STAFF BRIEF

Project: Spirit Plaza

Address: 1 E Jefferson Avenue

SPIRIT PLAZA IMPROVEMENTS

SHEET TITLE:
GATES AND
BOLLARDS

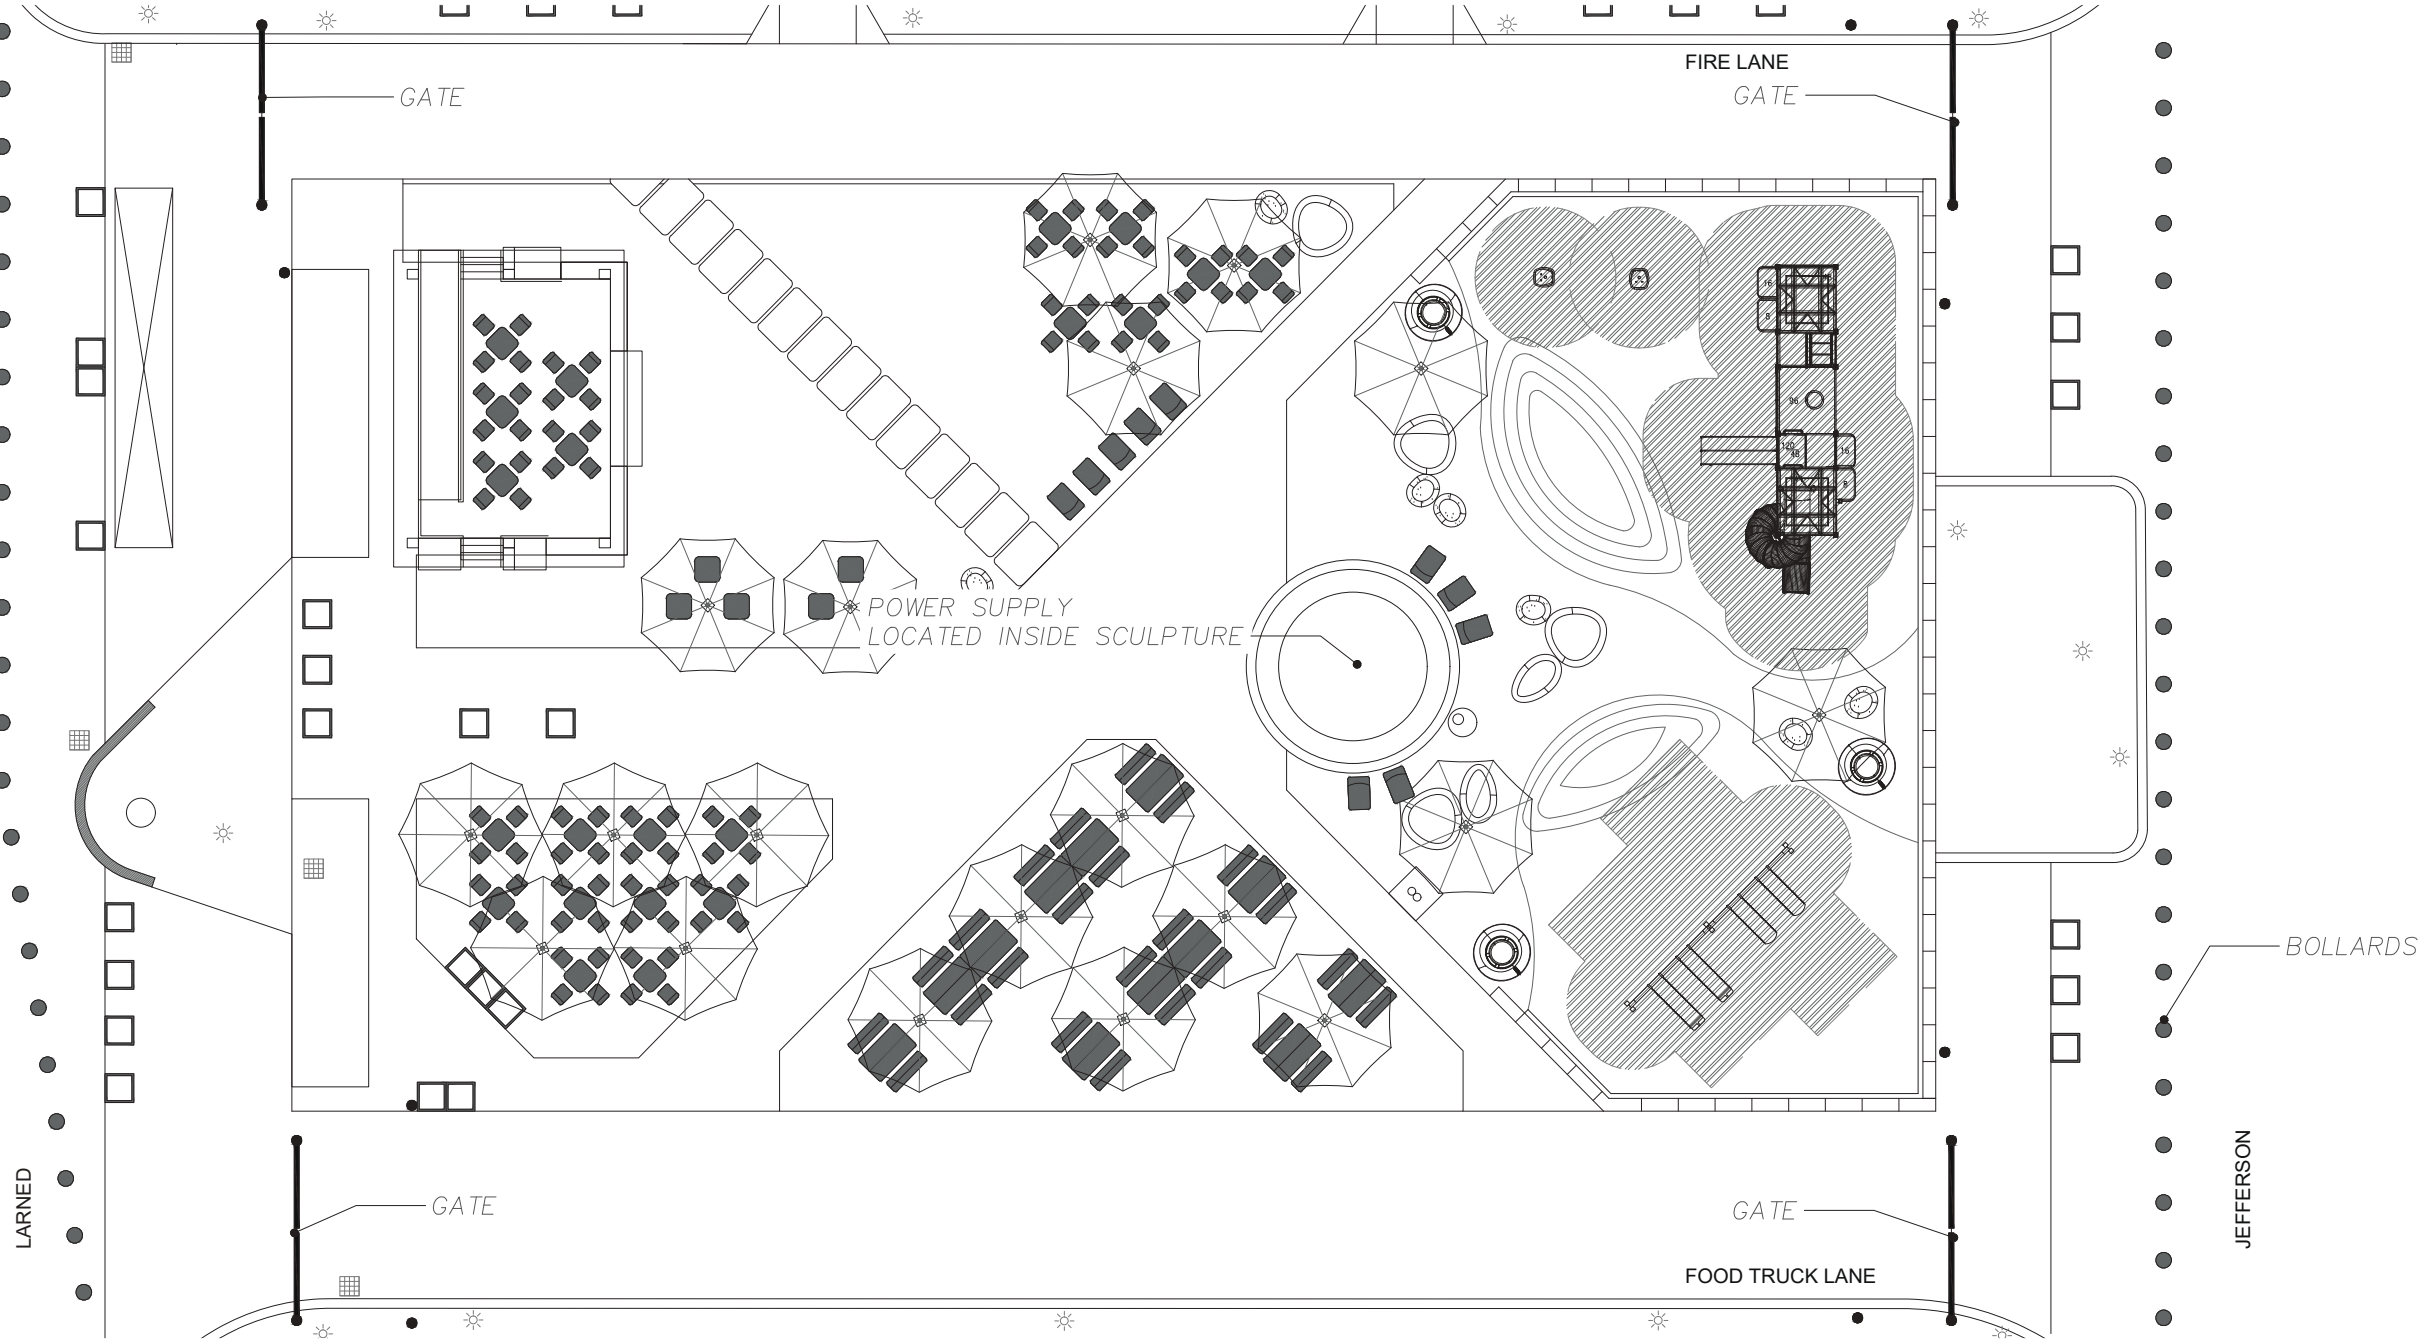
2./8. Are these bollards removable for food truck access?

SHEET TITLE:
SITE PLAN

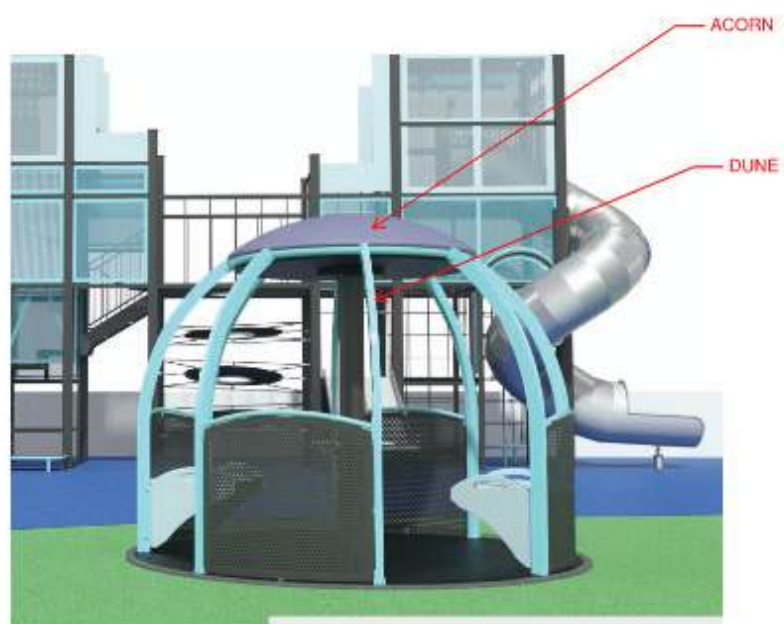
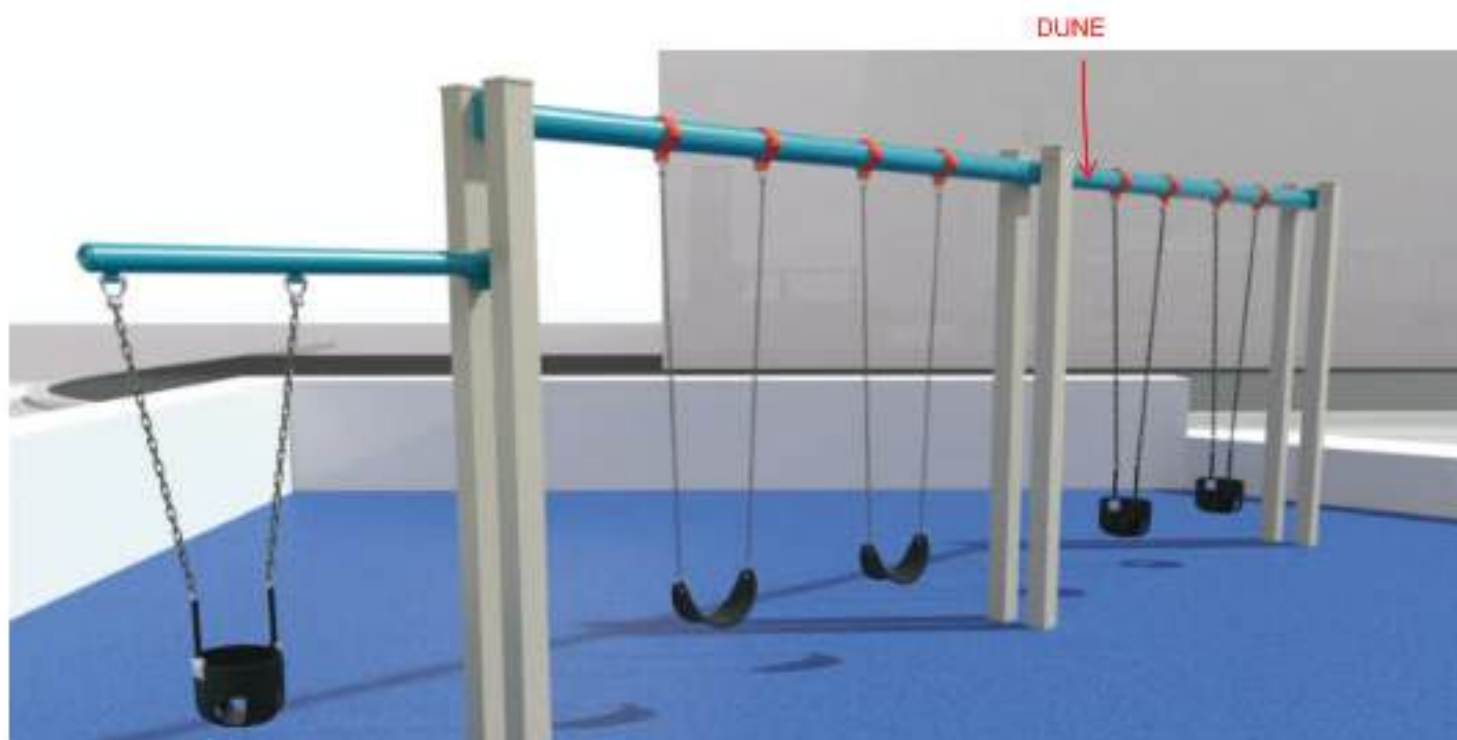
2. Clarify: What is the proposed screening? How are smells kept from traveling towards swings/ food truck area?

2. Clarify: Is there enough queuing space for food truck lines?
